**METROPOLITAN GOVERNMENT OF NASHVILLE AND DAVIDSON COUNTY**

**STAFF RECOMMENDATION**  
**1209 Paris Avenue**  
**December 18, 2013**

**Application:** Partial demolition; New construction—addition  
**District:** Belmont-Hillsboro Neighborhood Conservation Zoning Overlay  
**Council District:** 18  
**Map and Parcel Number:** 11801007800  
**Applicant:** Van Pond, Jr., architect  
**Project Lead:** Melissa Baldock, melissa.baldock@nashville.gov

Figure 1. 1209 Paris Avenue

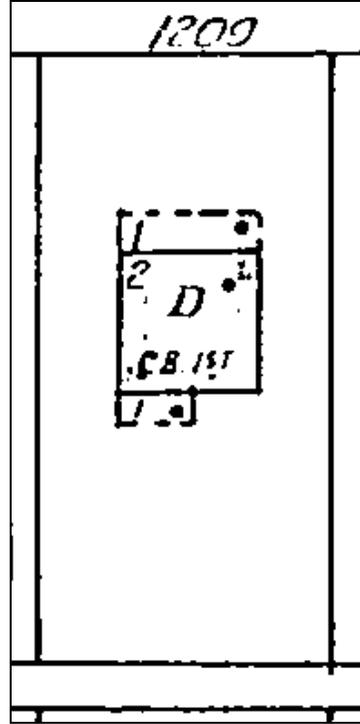
**Background:** 1209 Paris Avenue is a four square house constructed c. 1918 (Figure 1). It is a contributing structure to the Belmont-Hillsboro Neighborhood Conservation Zoning Overlay. In August 2012, MHZC staff issued an administrative permit to demolish the existing, non-historic porte cochere, but that permit has expired.

Figures 2 & 3. The side porte cochere is not original, and does not appear on the 1951 Sanborn map.

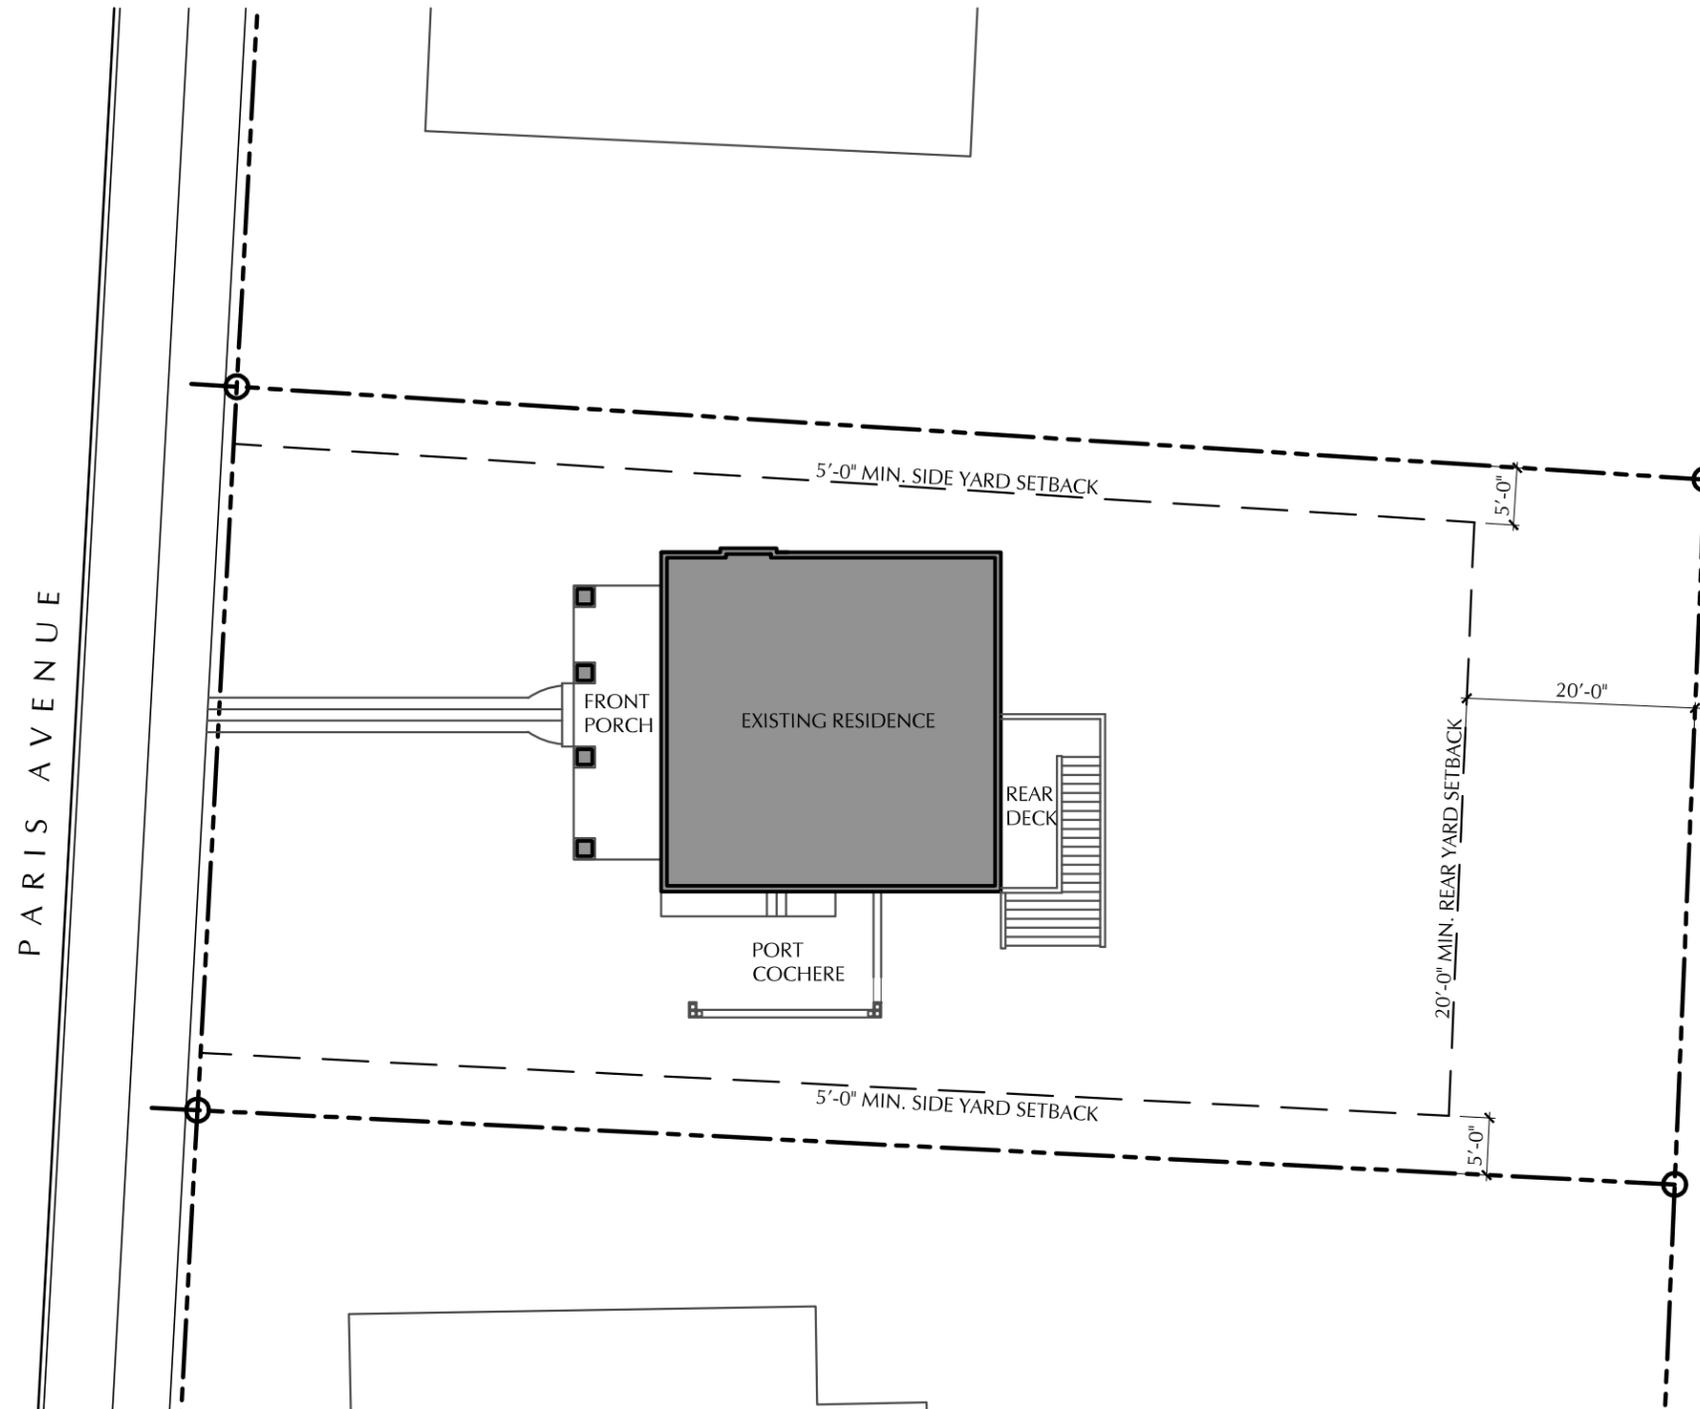
Demolition: The application involves demolishing the existing porte cochere (Figure 2). The porte cochere is not a historic element. It does not appear on the 1951 Sanborn Map, and its materials, design, and structural integrity do not contribute to the house's historic character (Figure 3). MHZC staff issued administrative permit to demolish the porte cochere in August 2012, but that permit has expired. Staff finds that the removal of the porte cochere will result in a more historically appropriate visual effect on the historic structure and the conservation overlay.

The project also involves removing most of the back wall of the historic house. Because the addition is inset two feet (2') from each of the back sidewalls, the back corners of the structure will remain. The original form of the historic house will therefore be discernable. In addition, because the rear wall of the house is not visible from the street, its removal will not significantly affect the historic character of the house or the district.

Staff finds that the removal of the porte cochere and the back wall of the historic house meets Section III.B.2. of the *Belmont-Hillsboro Neighborhood Conservation Zoning Overlay: Handbook and Design Guidelines*.

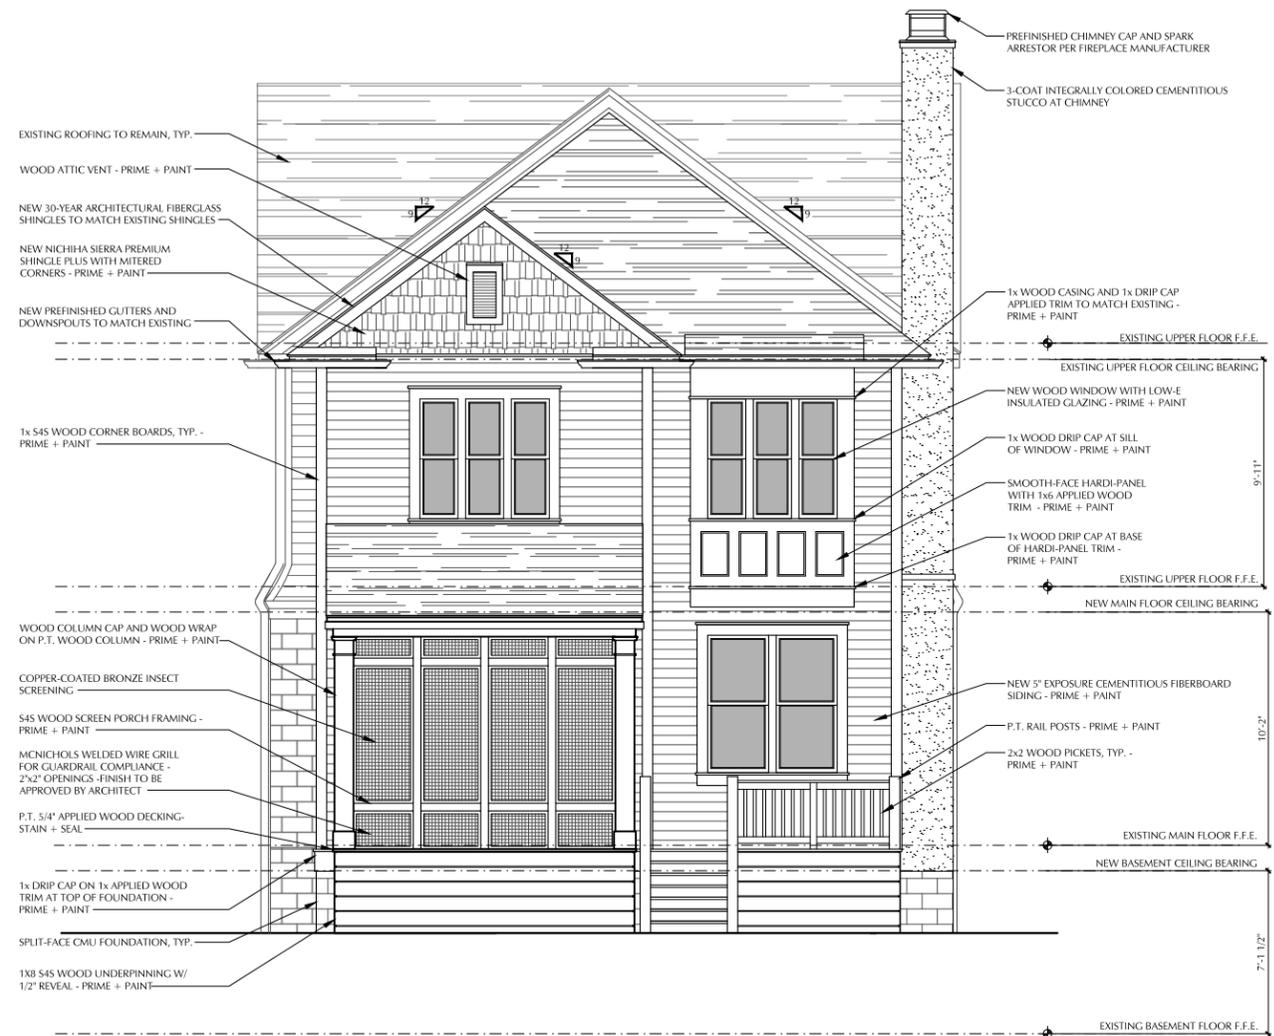
The windows on the proposed addition are all generally twice as tall as they are wide, thereby meeting the historic proportions of openings. On the right/west elevation, the windows on the ground floor are shorter than those on the second story. Although staff typically asks that windows on the ground floor be as tall or taller than those on the upper floors, staff finds that these proposed window sizes are appropriate because they occur on the addition, significantly back from the front of the historic house. There are no large expanses of wall space without a window or door opening. Staff finds the project's proportion and rhythm of openings to meet Section II.B.1.g. of *Belmont-Hillsboro Neighborhood Conservation Zoning Overlay: Handbook and Design Guidelines*.

1. Staff review the condition of the material underneath non-historic siding once the siding is removed to see if the historic material can be restored rather than replaced;
2. Staff review the window and door selections prior to purchase and installation;
3. HVAC be located on the rear façade, or on a side façade beyond the midpoint of the house.
